RE: Defect Information Report

Safety Recall Bulletin

Model	TUCSON (JM)
Group	AIR BAG SYSTEM
Number	HT-6-57-P03-JM
Date	April 5, 2007
Area	See Vehicles Affected below
Type	SAFETY RECALL

DRIVER AIR BAG MODULE REPLACEMENT

1. DESCRIPTION

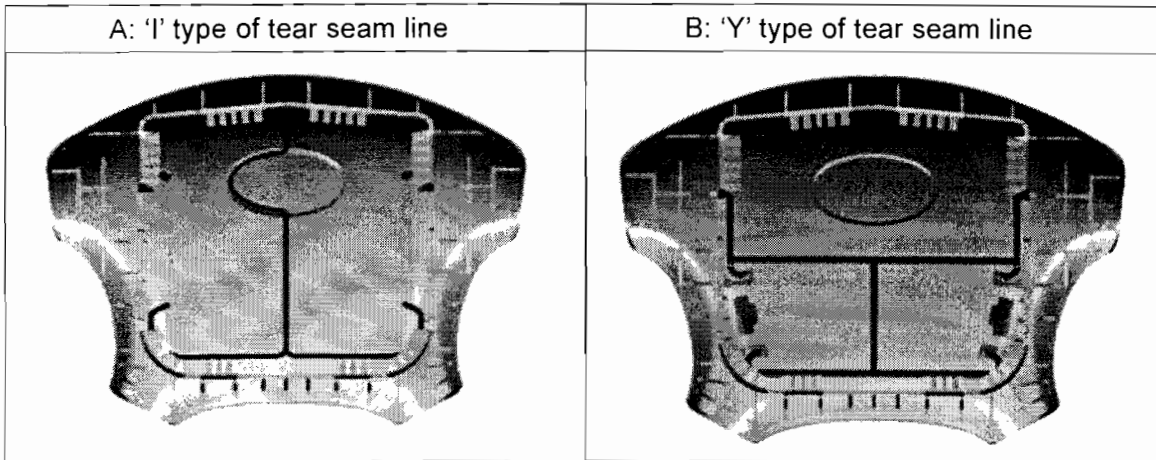
TUCSON (JM) driver air bag module had been produced with the **'I' shaped tear seam line (A)** on the cover. The driver air bag module must be replaced with new one with the **'Y' shaped tear seam line (B)** to increase the margin of compliance in the driver position fifth percentile female unbelted low risk deployment test.

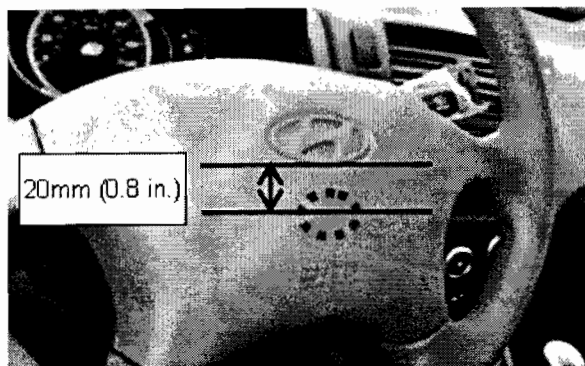
1) To discriminate between a previous DAB module and a new one, press the cover 20mm (0.8 in.) down from the 'H' logo. Previous DAB module cover can show 'I' shaped tear seam line and new one can show 'T' shaped tear seam line as shown in the pictures above.

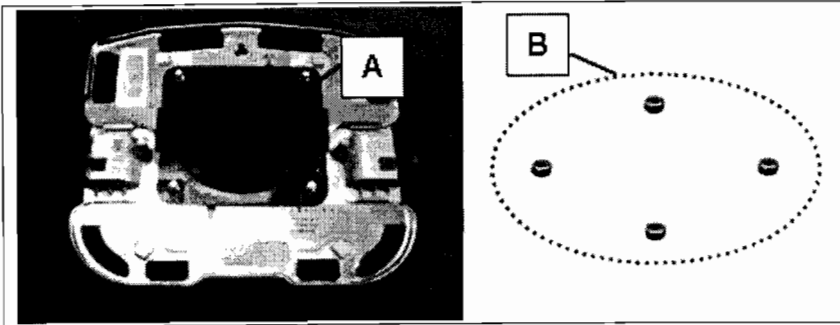
2) The DAB cover module to be newly supplied has the air bag inflator cover (A) and the four inflator mounting nuts (B), but does not have the inflator. Therefore, the existing

inflator must be re-used when replacing the DAB module with new one. Refer to the step 5 to 6 of the Service Procedure below.

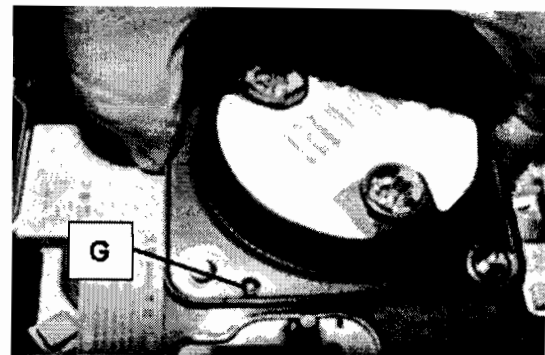
6. Remove the existing air bag inflator, align its hole (G) with the protrusion on the back of newly redesigned air bag cover module and re-install the inflator onto the new air bag cover module using newly supplied nuts.

**Inflator fixing nuts tightening torque:
0.7~0.9kgf-m (5.1~6.5lbf-ft)**
